### STAFF RECOMMENDATION 110 Lindsley Park Drive May 17, 2017

**Application:** New construction - infill  
**District:** Lockeland Springs-East End Neighborhood Conservation Zoning Overlay  
**Council District:** 06  
**Map and Parcel Number:** 08309048000  
**Applicant:** John Root, rootArch  
**Project Lead:** Jenny Warren, jenny.warren@nashville.gov

**Description of Project:** Application is to construct a new single-family residence on a vacant lot.

**ARCHITECTURAL SITE PLAN - 110 LINDSLEY PARK**

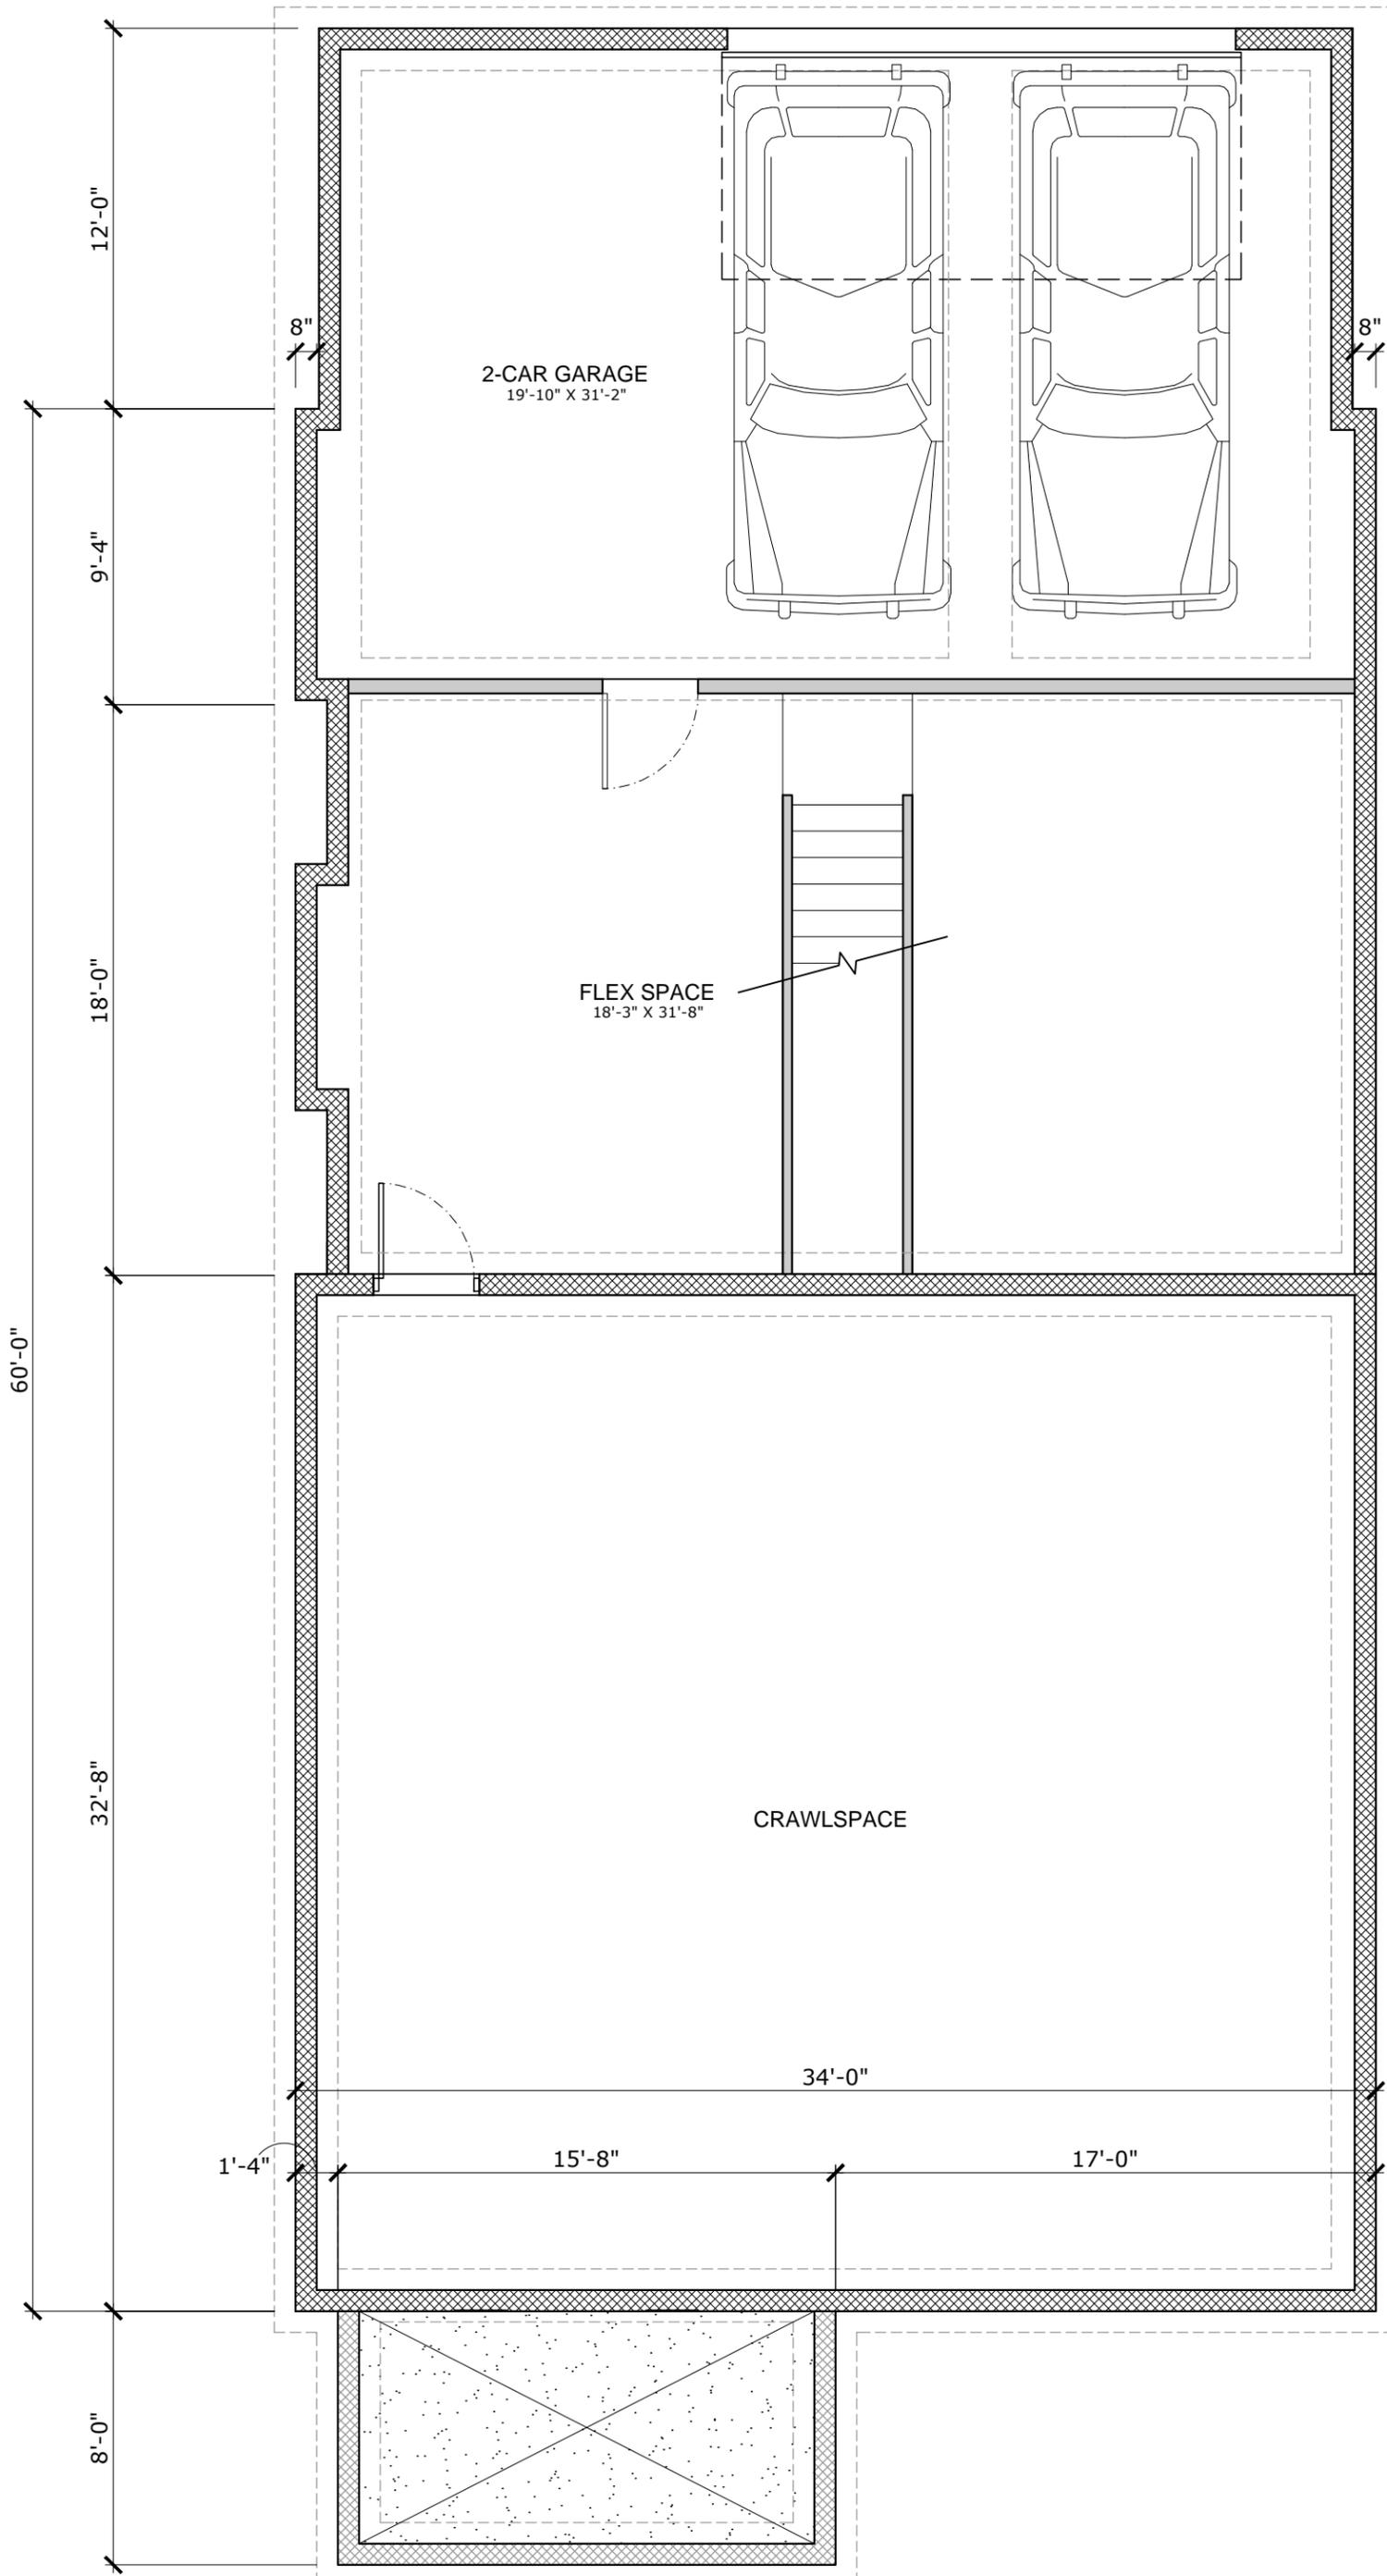
Appurtenances & Utilities: The infill includes a walkway leading from the street to the front porch. The driveway will be located from the rear of the lot with a curb cut from South Fifteenth Street. The location of the HVAC and other utilities was not noted on the plans. Staff asks that the HVAC be located on the rear façade, or on a side façade beyond the midpoint of the house, to ensure that the project meets section II.B.1. i.

1. A new north elevation and site plan be submitted, prior to issuance of a permit, showing four total windows on the north elevation, first level.
2. The finished floor height be consistent with the finished floor heights of the adjacent historic houses, to be verified by MHZC staff in the field;
3. Staff approve the final details, dimensions and materials of windows, doors, garage doors, porch railing, porch posts, driveway material, masonry, and walkway material prior to purchase and installation; and
4. The HVAC shall be located behind the house or on either side, beyond the midpoint of the house.

NORTH ELEVATION - 110 LINDSLEY PARK

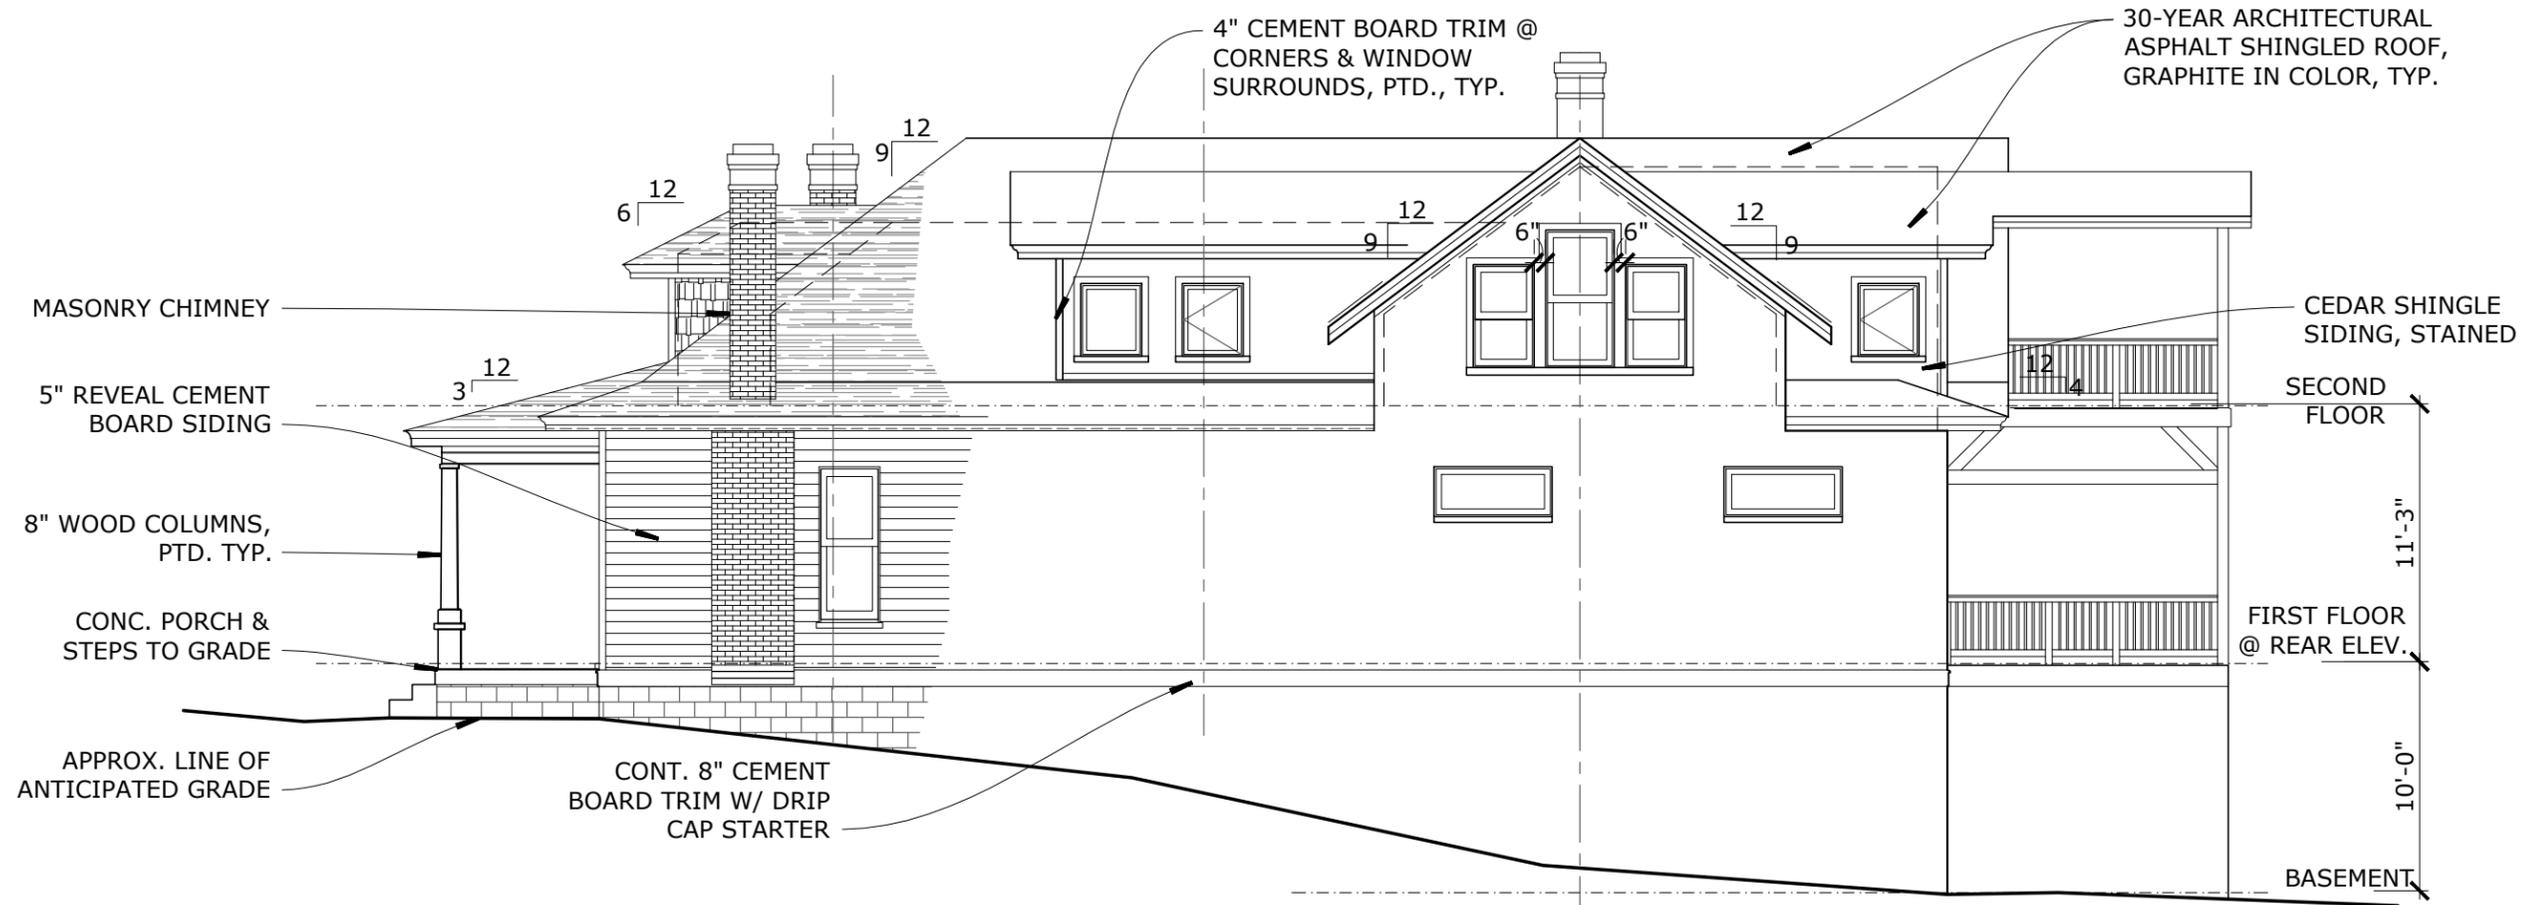
Proportion and Rhythm of Openings: Most of the windows on the proposed infill are generally twice as tall as they are wide, thereby meeting the historic proportions of openings. The plan does include two smaller horizontal windows on the left side façade. Staff, however, finds that these windows could be appropriate given their locations and the change in grade on site as they will not likely be visible from the street. On the north elevation, first level, there is an approximately twenty-three foot (23’) section of wall with no window opening. Staff recommends a revision of the north elevation and the

floor plan before permitting to assure that a window is included, as it is necessary to meet the appropriate rhythm of openings.
